35-TYPE CONVERTER SETS — ADJUSTMENTS

APPARATUS AFFECTED: 35A, 35B, 35D, 35E, 35F, 35G and 35H Converter Sets.

- (1) To simplify adjustment methods and requirements.
- (2) To revise and update wiring diagrams.

8.19 GEAR MECHANISM**(A) INTERMEDIATE SHAFT****REQUIREMENT**

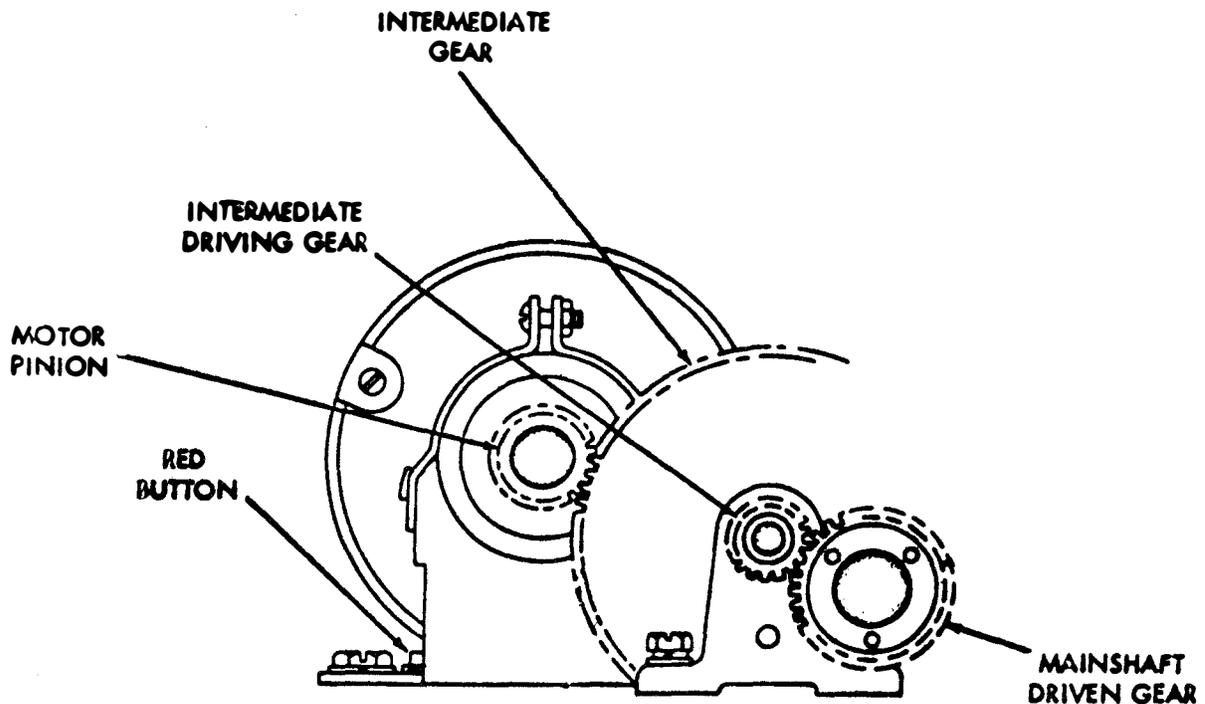
CHANGE: Changes have been made in the following adjustment requirements:

(1A) *Section 570-106-700, Issue 3, Page 30, Paragraph 3.19*

(A) Tape Reader Gear Backlash

The location of subparagraph (A) on page 30 has been changed and will read as subparagraph (B) Tape Reader Gear Backlash.

The requirement (A) Tape Reader Gear Backlash has been changed:

From: "Only a perceptible amount of backlash between main shaft driven gear and intermediate driving gear."

To: "Only a perceptible amount of backlash between main shaft driven gear and intermediate driving gear at point where backlash is least."

(B) Intermediate Shaft

The location of subparagraph (B) on page 30 has been changed and will read as subparagraph (A) Intermediate Shaft.

The requirement of Min. 0.015 inch—Max. 0.020 inch has been deleted.

"To Adjust" of new (A) Intermediate Shaft, has been changed:

From: To Adjust.

Position the intermediate shaft assembly to the forward plate loosened.

To: To Adjust.

Loosen the two intermediate gear bracket screws and position intermediate gear bracket.

The note to subparagraph (B) Intermediate Shaft, has been changed:

From: Note: Intermediate shaft adjustment required only on miniaturized base.

To: Note: In some cases, it may be necessary to loosen the motor mounting screws and position the motor to meet the requirements.

The new requirements are shown on attached sheet which should be used as temporary addendum to page 30, Section 570-106-700.

ONLY A PERCEPTIBLE AMOUNT OF BACKLASH BETWEEN THE MOTOR PINION AND INTERMEDIATE GEAR AT POINT WHERE BACKLASH IS LEAST.

TO ADJUST

LOOSEN THE TWO INTERMEDIATE GEAR BRACKET SCREWS AND POSITION INTERMEDIATE GEAR BRACKET.

NOTE: IN SOME CASES IT MAY BE NECESSARY TO LOOSEN THE MOTOR MOUNTING SCREWS AND POSITION THE MOTOR TO MEET THE REQUIREMENT.

**(B) TAPE READER GEAR BACKLASH****REQUIREMENT**

ONLY A PERCEPTIBLE AMOUNT OF BACKLASH BETWEEN MAINSHAFT DRIVEN GEAR AND INTERMEDIATE DRIVING GEAR AT POINT WHERE BACKLASH IS LEAST.

TO ADJUST

LOOSEN THREE TAPE READER MOUNTING SCREWS AND POSITION TAPE READER.
